Crookwell 3 Wind Farm

Landscape & Visual Impact Assessment Supplementary Report

Response to Independent Expert Review
Ref: 918-Z-02, Dated August 2013

22 January 2014

Figure SR1
Distance effect

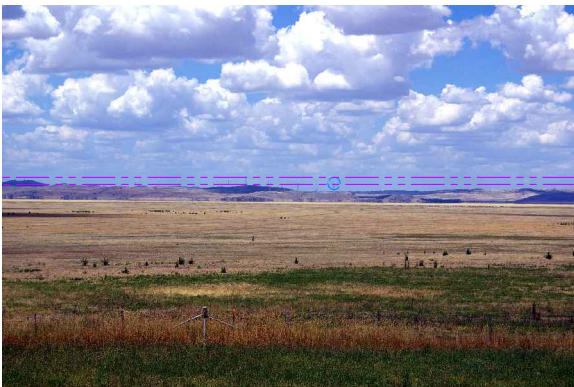
- ***an assessment of the effect of proposed turbine height on dominance and required setbacks in the study area landscape***

With an increase in distance the proportion of a person's horizontal and vertical view cone occupied by a visible turbine structure, or group of turbine structures, will decline. In order to demonstrate this a series of single frame photographs have been taken from pre-set distances (1.5 km, 4 km, 7 km and 10 km) toward wind turbines at the Capital wind farm in New South Wales. The photographs, illustrated in **Figure SR1**, demonstrate the degree to which the apparent visible height of a wind turbine decreases with increasing distance (in a negative exponential relationship), and the increasing amount of horizontal skyline visible with an increasing distance.

Figure SR2
Residential View Locations

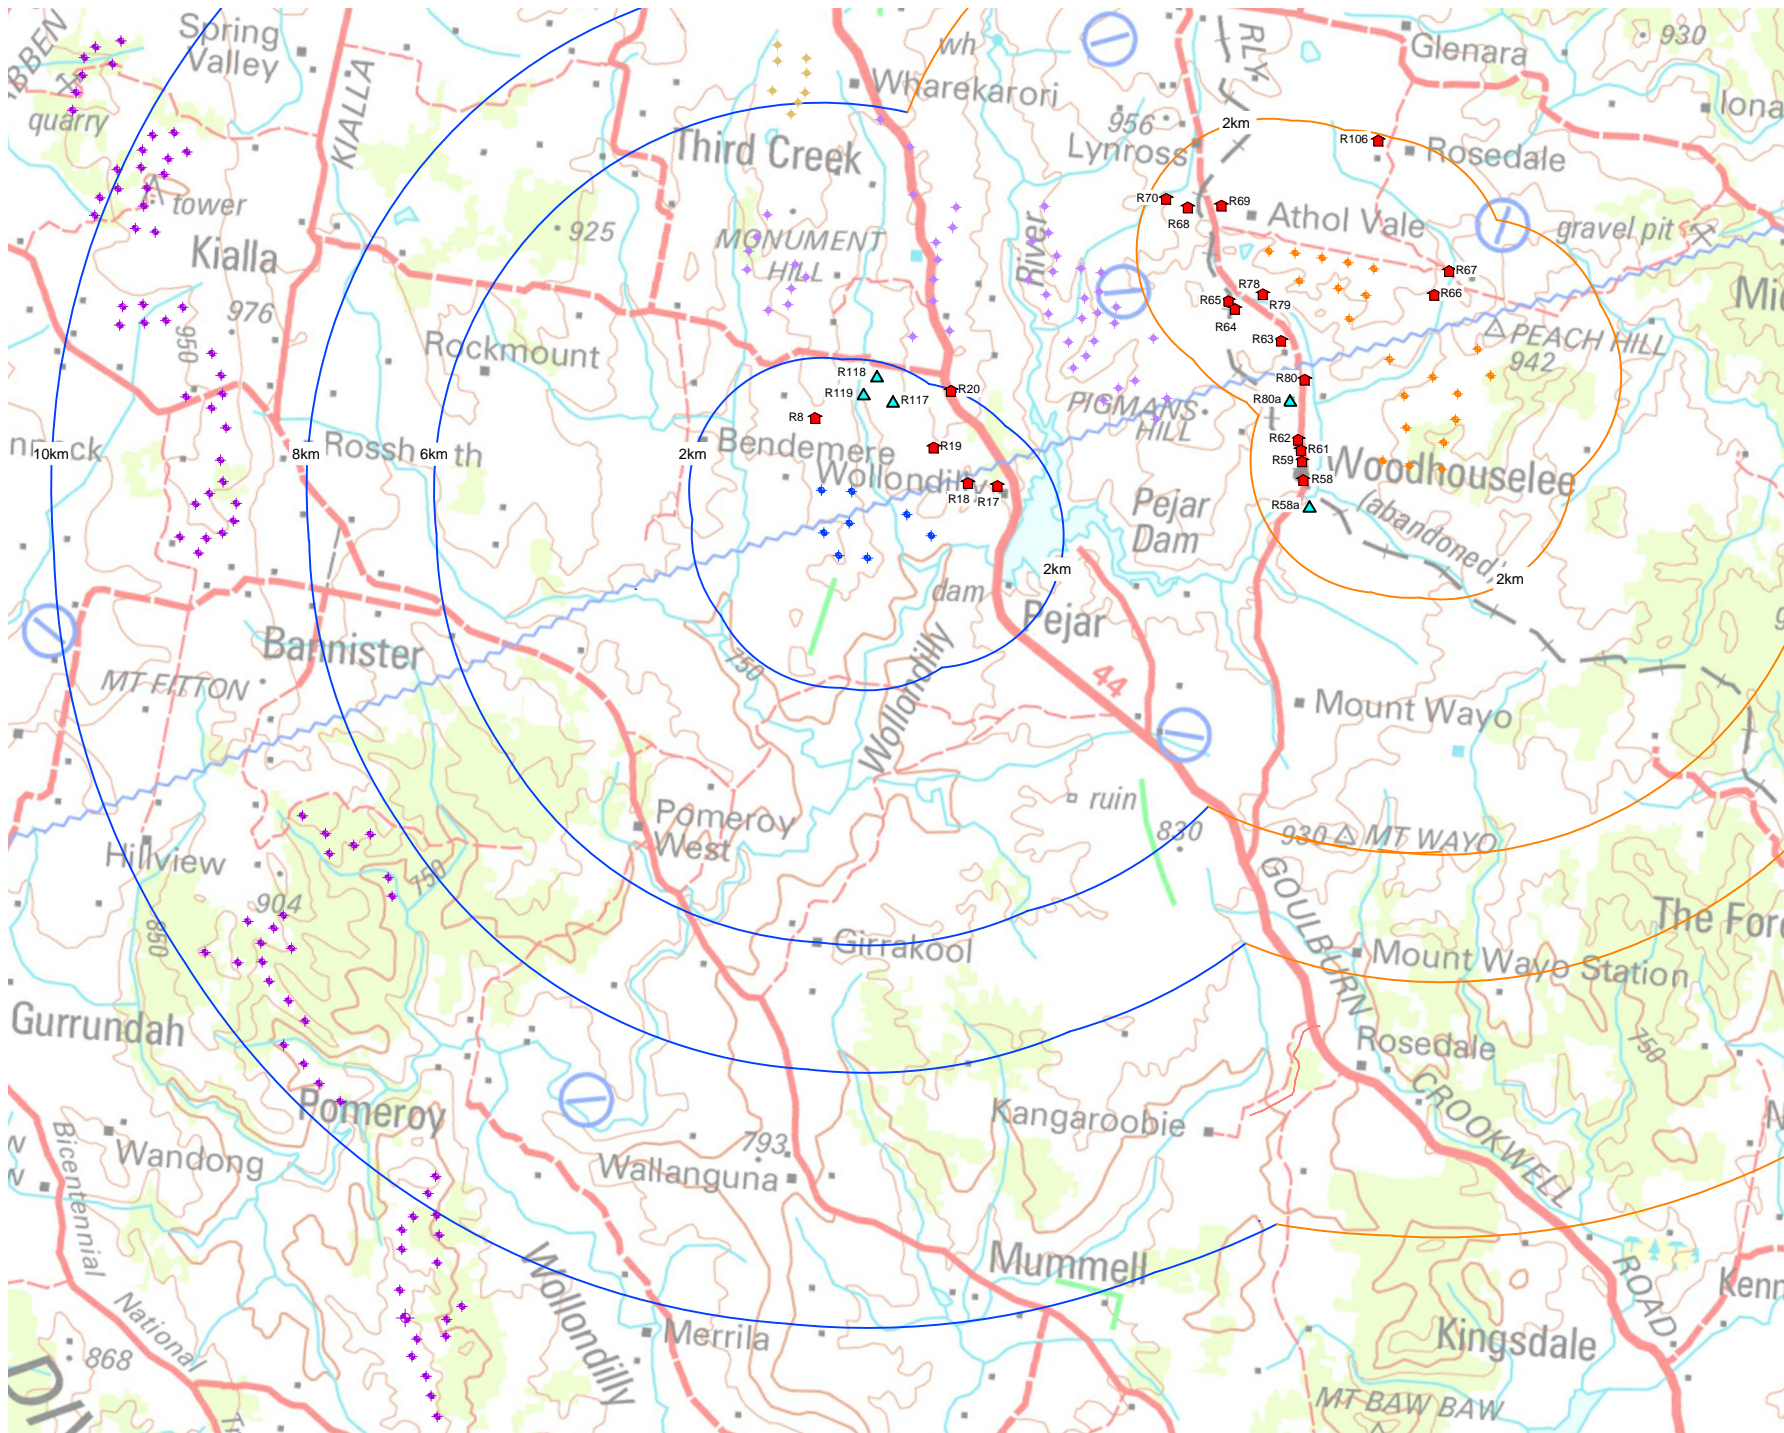
- ***Provide a justified methodology and assessment of the cumulative impacts of Crookwell 3 combined with Crookwell 1, 2 and Gullen Range including both approved and proposed elements;***
- ***Clearly identify any likely changes to the landscape character of the region resulting from the combination of the regional projects and identify the regional community perceptions of the resultant cumulative impacts based on surveys and consultation, and***
- ***Include assessments of the cumulative impact of the regional projects on public viewing locations, heritage items and individual residences, particularly residences within 2 km of any proposed Crookwell 3 wind turbine.***

The location of the residential dwellings within 2 km of the Crookwell 3 wind turbines are illustrated in **Figure SR2**.
